To: Case Officer – Mr George Clarke
Development Environment
Development Management
6th Floor
Bernard Weatherill House
8 Mint Walk
Croydon
CR0 1EA

From:
Monks Orchard Residents' Association
Planning

Reference:	19/01352/FUL
Application Received:	Wed 20 Mar 2019
Application Validated:	Wed 20 Mar 2019
Address:	56 Woodmere Avenue Croydon CR0 7PD
Proposal:	Demolition of a single-family dwelling and erection of a 3- storey block containing 2 x 3-bedroom, 6 x 2-bedroom and 1 x 1-bedroom apartments with associated access, 7 parking spaces, cycle storage and refuse store.
Consultation Close:	Thu 18th April
Target Date:	Wed 15 May 2019
Case Officer:	George Clarke

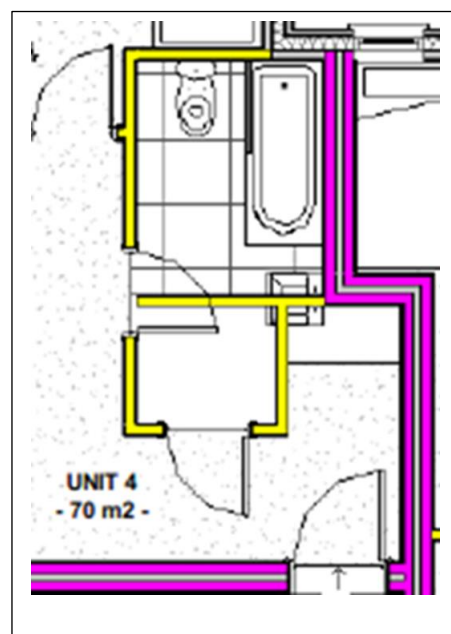
Also, Unit 4 has the door to the Bathroom which **fails** the **cupboard/bathroom wall** and would be **impossible** to open to allow access to the bathroom; the dividing wall is also built across the hand basin (**See illustration right**).

Rear aspect of 54 Woodmere Avenue

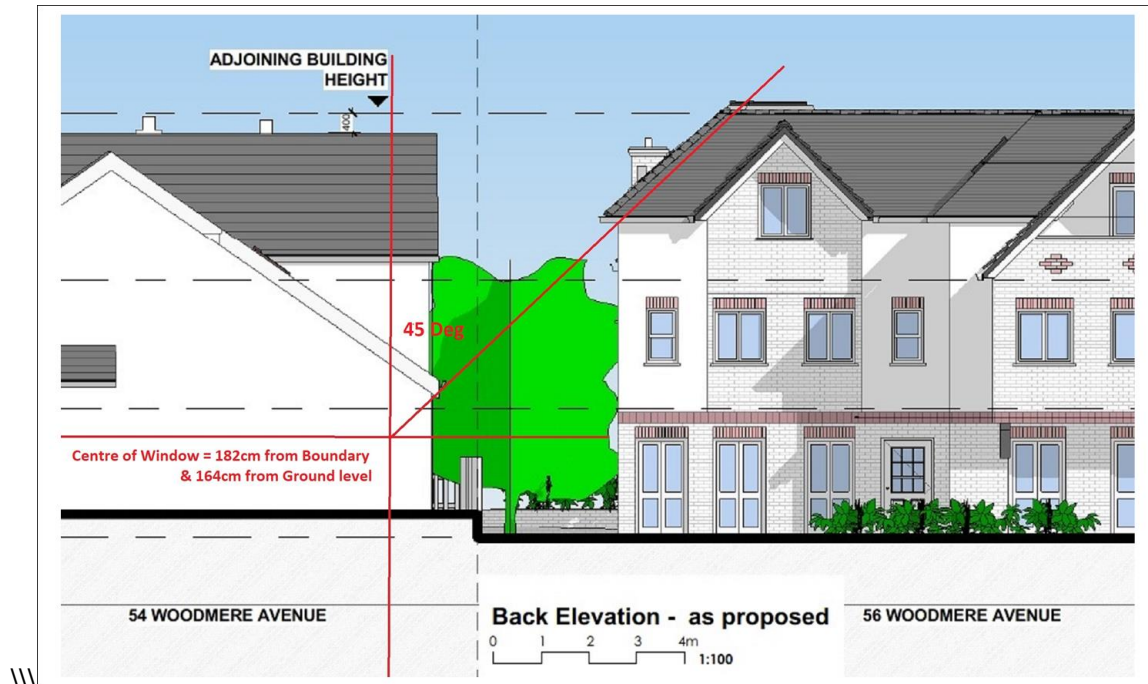
The Supplementary Planning Document SPD2, (adopted 1st April 2019) **Chapter 2 Suburban Residential Developments** at **Para 2.11 Heights & Depths Projecting beyond Building Lines** at pages **36 & 37** describes a **45° rule** for new developments with adjacent properties. The owner of **54 Woodmere Avenue** has provided the measurements for the Centre

of the ground floor window at **182cm** from the boundary and **164cm** from ground level.

This illustrates that the proposed development **fails to meet the 45° rule on height (see below) and will intercept the 45° projection** in relation to the **adjacent property**. It should be recognised that the proposed development is to be **sunk into a 0.6m hole in the ground** in order to meet the adjacent properties height restriction. **If the built form is NOT actually sunk into the ground**, the built form would be **0.6m higher** and the projected **45° Rule** would show much more of the proposed development would be **above the 45° intercept projection** and significantly greater

These projections are based upon the provided plans with dimensions scaled off when magnified at 112% which gives 1cm = 1m. This illustrates an overbearing nature of the proposed development on the adjacent property at **54 Woodmere Avenue**.

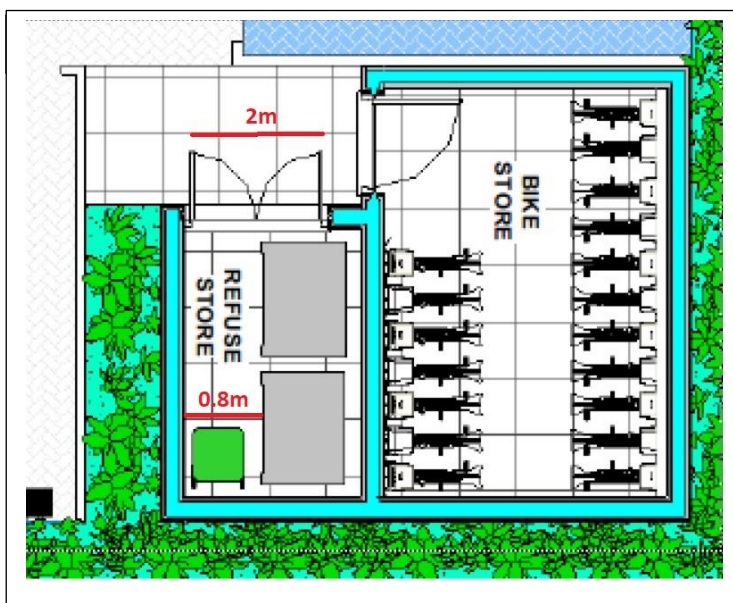
It is understood that there must be a minimum of **150mm clearance** around and between each bin within a storage area. Where there is more than **one bin within a storage area**, as is the case for this proposed development, there must be **2m clearance in front of each bin** to enable it to be accessed and safely moved without needing to move any of the other containers. The proposed development **does not provide this 2m clearance** in front of the bins to allow safe movement.

It is also understood that the access doors to the bin storage must **not open outward** over a **public footway or road**, and should **not** cause any **obstruction** to other accesses when in an open position. The proposed development Refuse Storage doors **DO** open outwards and **DO obstruct access to the adjacent Bike store.**

It is understood that a water supply, with standard tap fittings be available to the bin storage area to enable washing down of the bins, walls and floor. This requirement is not shown on the plans.
